Access Compliance Report

Public Rights-of-Way

(Curb Ramps)

Intersection ID: 12527	Main Street: E_7TH_ST	Cross Street: N_DAVIDSON_ST	Location: W
ADA ID: 4C58678AB930	Ramp Type: PerpDiag	Initial Pass/Fail: Fail	Overall Compliance: No
Severity Score: 35			
Codes/Mitigation Info/Possible Solution		Field Measurements/Component Compliance

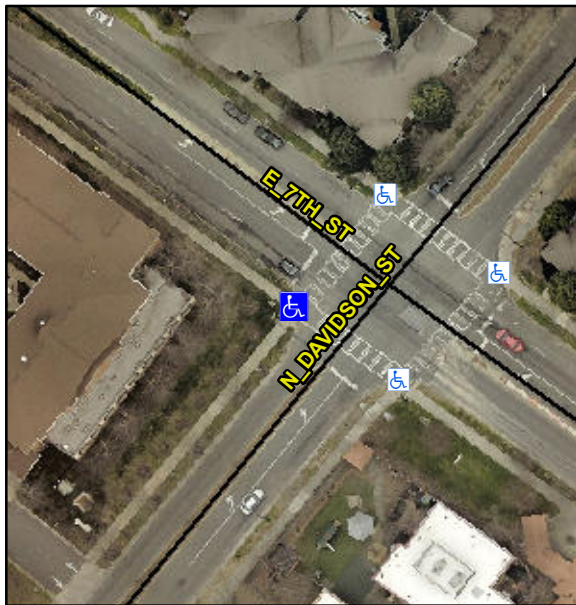
Not Found, R304.5.1

Compliance	Description	Data	Compliance	Description	Data
N/A	Ramp Length (in)	82.0	Yes	Ramp Slope (%)	7.9
No	Ramp Width (in)	30.0	Yes	Ramp XSlope (%)	0.3
N/A	Flare Type LT	N/A	N/A	Flare Type RT	N/A
N/A	Flare Slope LT (%)	N/A	N/A	Flare Slope RT (%)	N/A
N/A	Flare Traversable LT?	N/A	N/A	Flare Traversable RT?	N/A
N/A	Landing Length (in)	N/A	N/A	DWS Provided?	N/A
N/A	Landing Width (in)	N/A	N/A	DWS Contrast?	N/A
N/A	Landing Slope (%)	N/A	N/A	DWS Length (in)	N/A
N/A	Landing X Slope (%)	N/A	N/A	DWS Full Width?	N/A
N/A	Landing Curb? (Y/N)	N/A	N/A	DWS Offset (in)	N/A
N/A	Shared Landing?	N/A			
N/A	Gutter Ponding?	N/A	N/A	Gutter Slope (%)	N/A
N/A	Gutter Lip Ht (in)	N/A	N/A	Gutter X Slope (%)	N/A
N/A	Painted X Walk1?	Yes	N/A	Painted X Walk2?	Yes
	X Walk 1 Direction	To SE		X Walk 2 Direction	To NE
N/A	X Walk 1 Width (in)	111.0	N/A	X Walk 2 Width (in)	100.0
	X Walk 1 Slope (%)	0.5		X Walk 2 Slope (%)	3.9
	X Walk 1 X Slope (%)	2.1		X Walk 2 X Slope (%)	0.2

Remove & Replace Curb Ramp With Two New Directional Ramps or Equivalent.
